Spokane Design Review Board

5:40 – 7:40	5) Latah Glen PUD – Recommendation Meeting	Taylor Berberich
	• Staff Report.....	15-20 m
	• Applicant Presentation.....	25 m
	• Public Comments and Board Q & A	25 m
	• Board Discussion and Motion(s).....	45 m

CONTEXT/SITE ANALYSIS LATAH GLEN RESIDENTIAL COMMUNITY

SITE PLAN LATAH GLEN RESIDENTIAL COMMUNITY

SITE PLAN - DESIGN CHARACTER

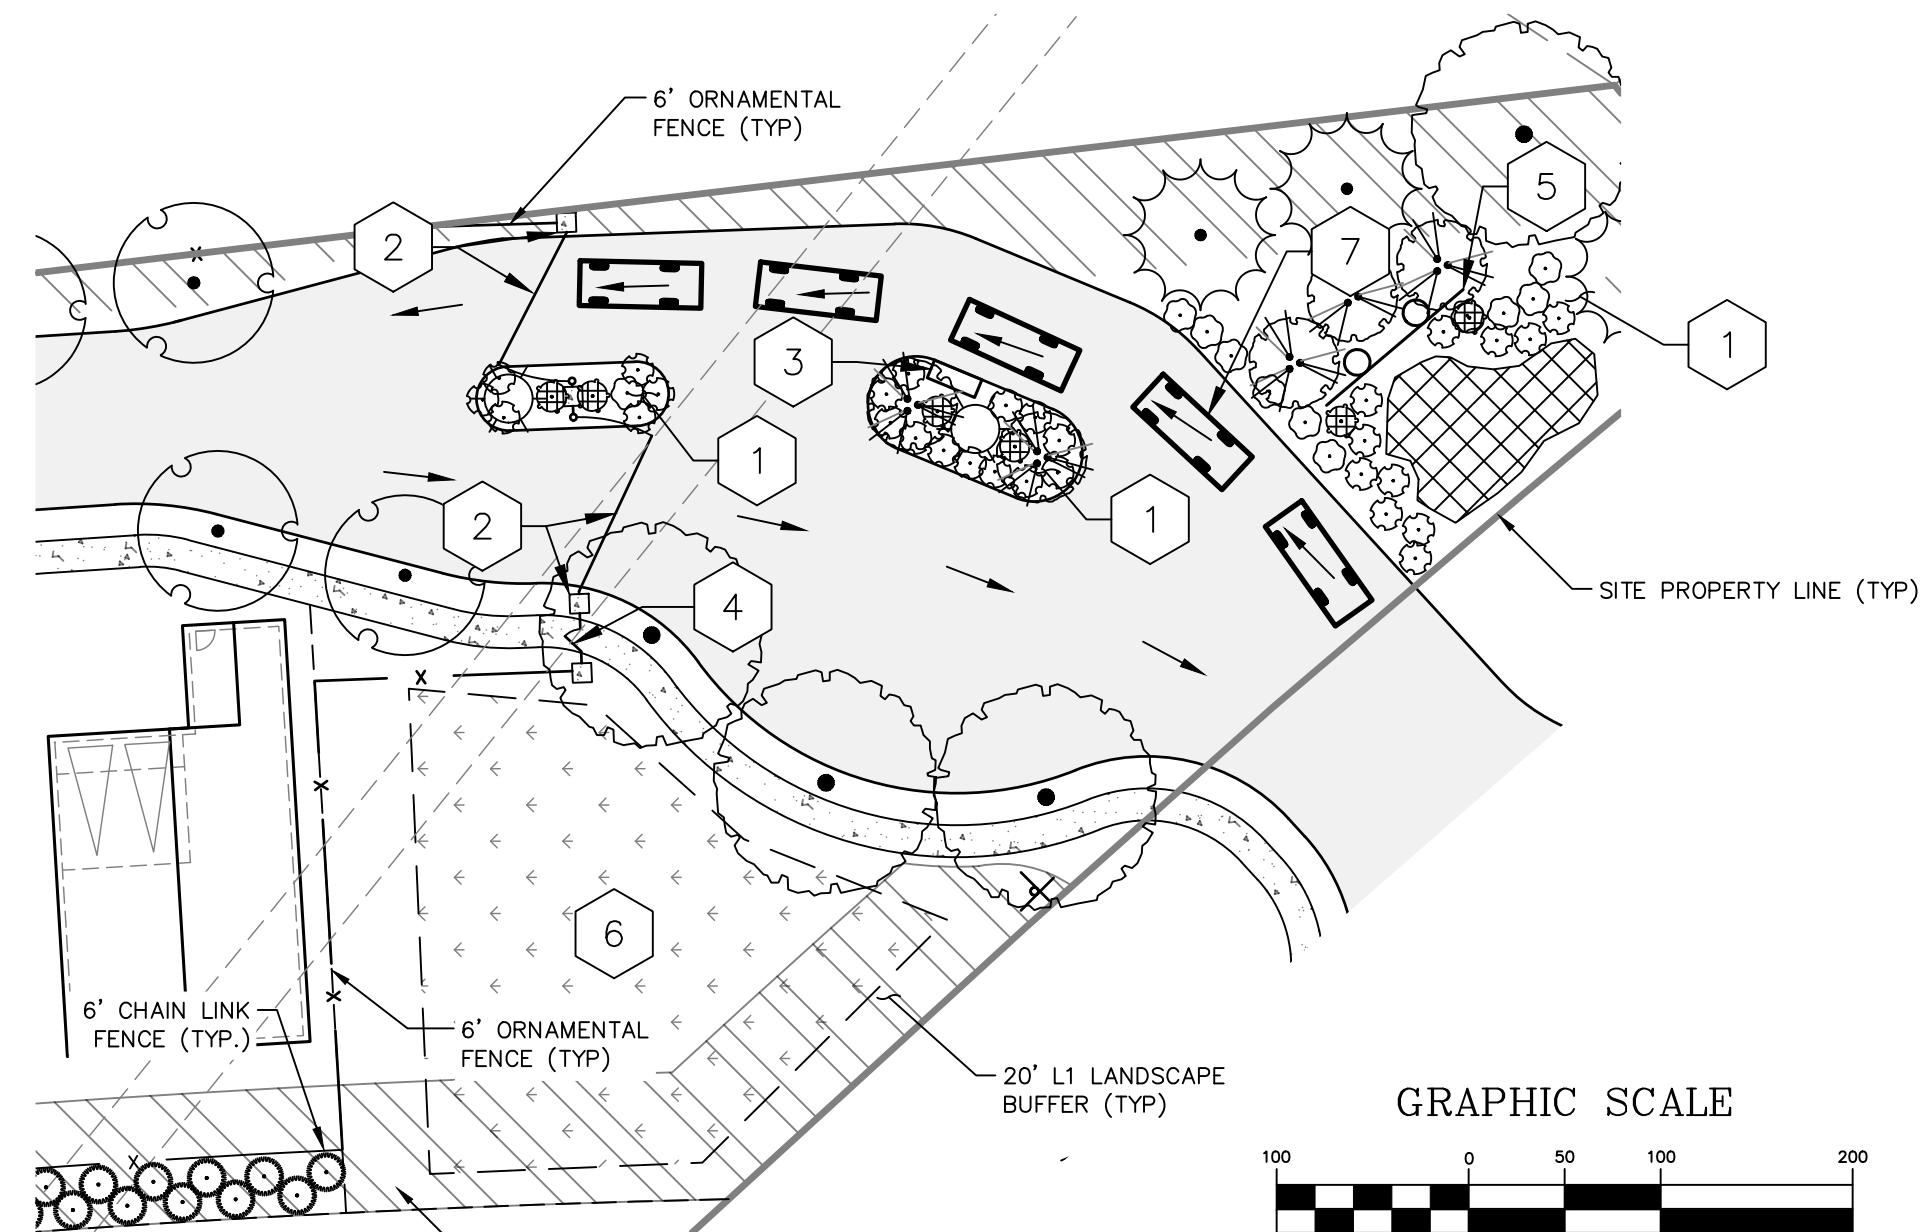
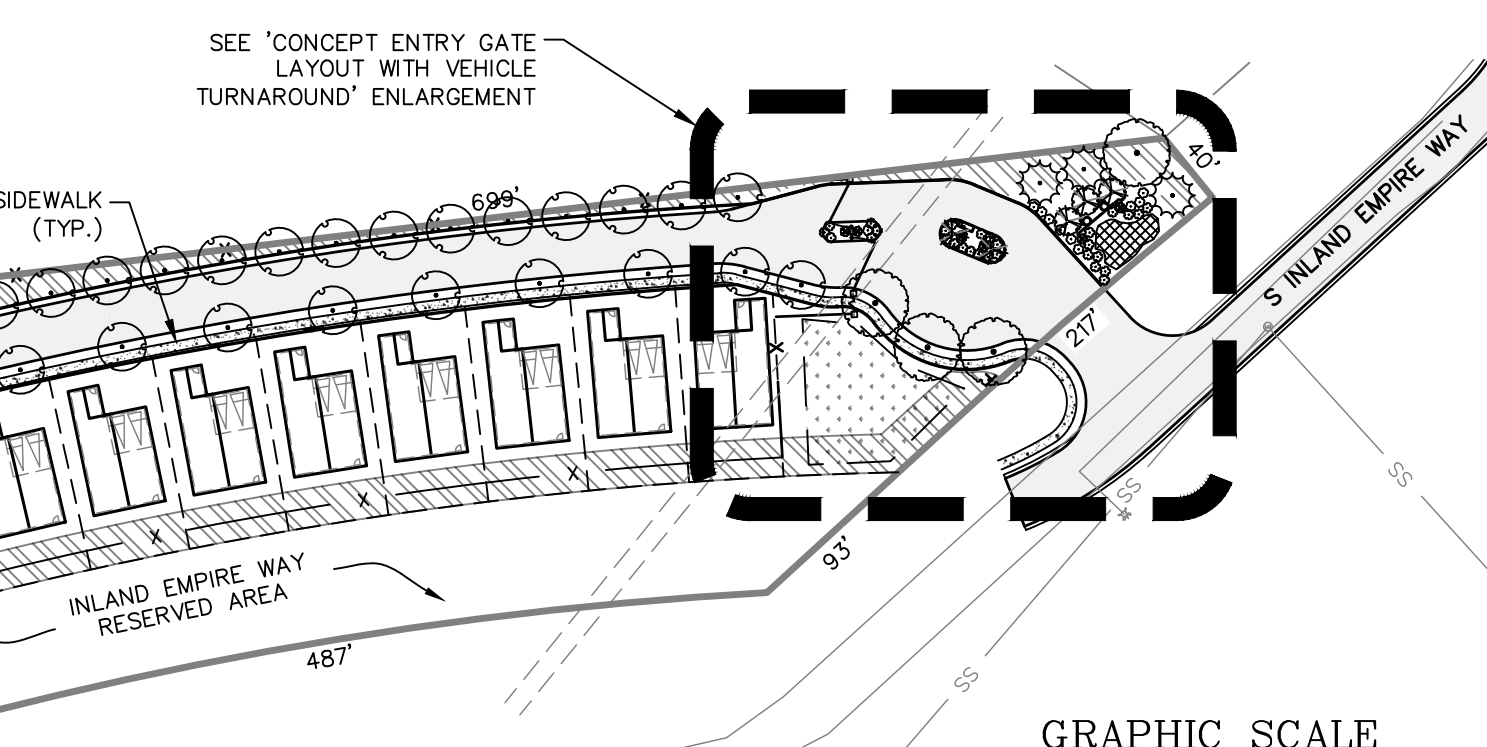
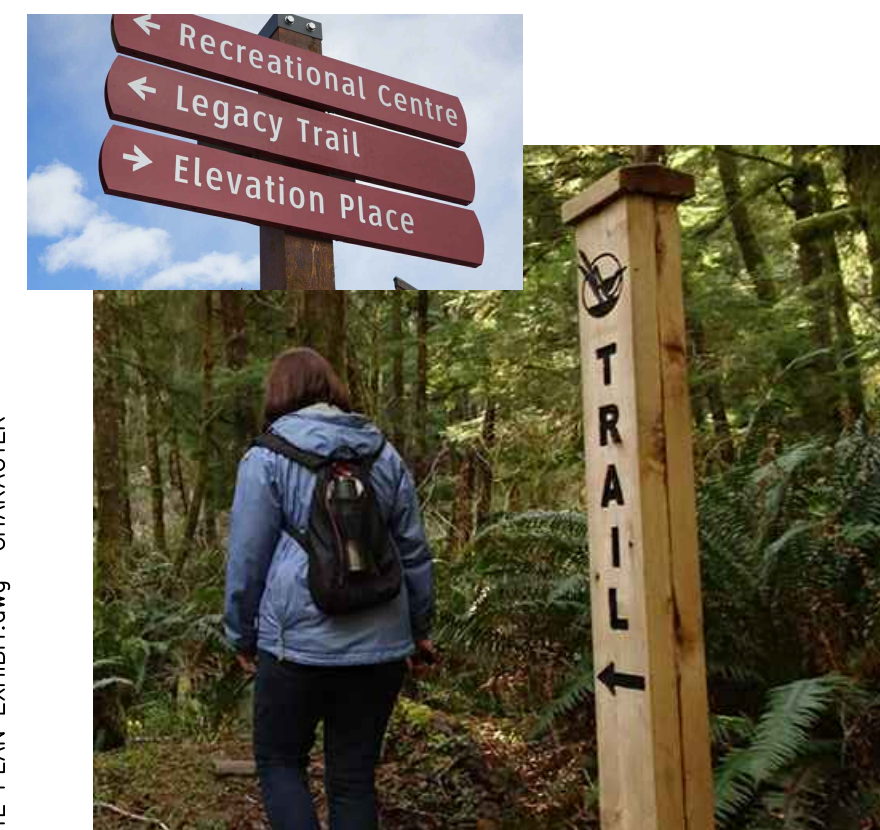
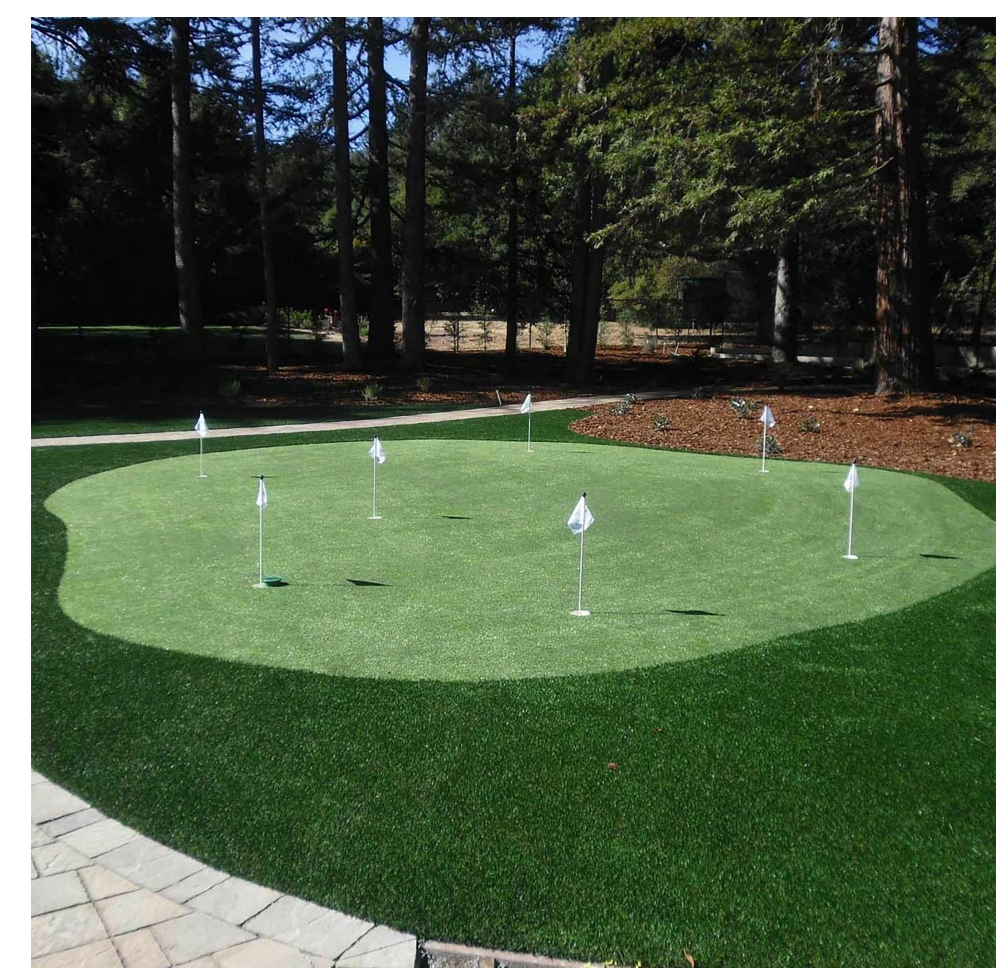
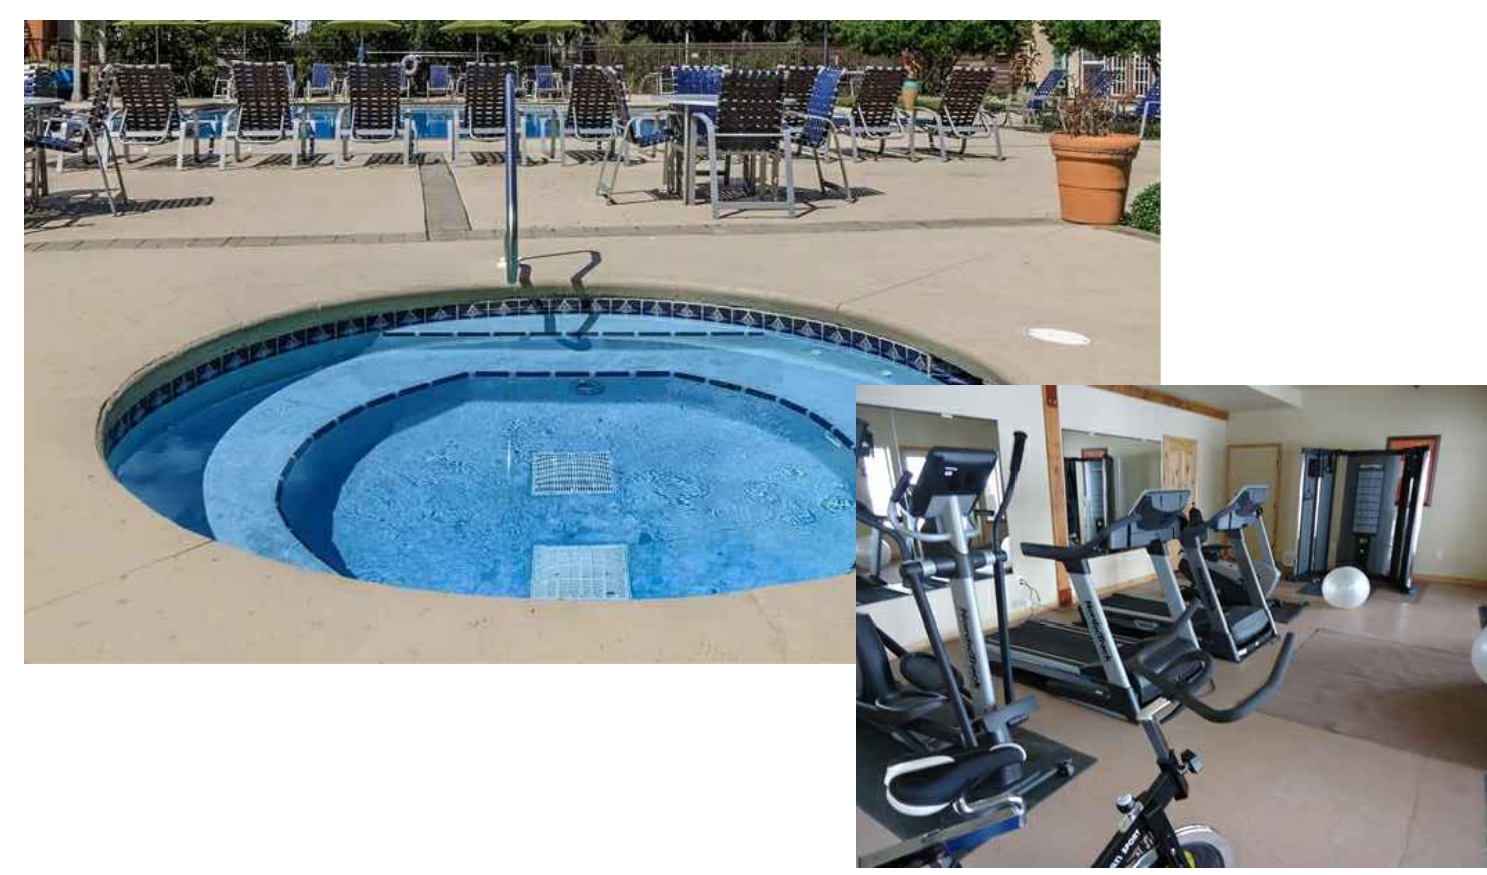
- 3. The Applicant is encouraged to return with a more fully developed plan illustrating intended innovation in stormwater treatment.**

1. As indicated on the Applicant's site plan, there are three bioretention swales that fall within the L1 landscape buffer. Does the board have a recommendation regarding selection of plant species that will thrive in a damp/swamp environment which may not receive supplemental irrigation?

2. According to page 3 of the Applicant's Site Design PDF (*Site Plan- Design Character) street trees along the western-most north/south running street (Private Road-3) are only shown on the downhill/eastern slope. Does the uphill/western slope provide an opportunity for street trees, and does the board have a recommendation to provide?
3. Is there an opportunity to match the aesthetics of the westernmost emergency vehicle access gate and pedestrian gate leading to Fish Lake Trail to the aesthetics of the entry gate, in order to provide a cohesive site character?
4. As the Applicant's Site Plan is unclear if power and telecommunications is intended to be provided through overhead utility lines, does the board have a recommendation for reducing the visual impact of such overhead lines?

Conceptual bioretention stormwater swales have been indicated on the attached 'Site Plan-Design Character' sheet. Character images of bioretention-style plantings instead of the ubiquitous '208' turf swale are included. Final planting design of bioretention swales will be in accord with the Eastern Washington Low Impact Development Guidance Manual.

A tree palette with street trees included has been added and concept tree types and locations shown on the attached 'Site Plan-Design Character' sheet.

A native dryland hydroseed is indicated and planned on the existing unvegetated slope area with Ponderosa Pines planted as feasible on the attached 'Site Plan - Design Character' sheet.

- b. Conceptual bioretention stormwater swales have been indicated on the attached 'Site Plan – Design Character' sheet. Character images of bioretention-style plantings instead of the ubiquitous '208' turf swale are included. Final planting design of bioretention swales will be in accord with the Eastern Washington Low Impact Development Guidance Manual.

4. The Applicant shall return with a proposed street tree palette.
 - a. A tree palette with street trees included has been added and concept tree types and locations shown on the attached 'Site Plan – Design Character' sheet.

- a. A native dryland hydroseed is indicated and planned on the existing unvegetated slope area with Ponderosa Pines planted as feasible on the attached 'Site Plan – Design Character' sheet.
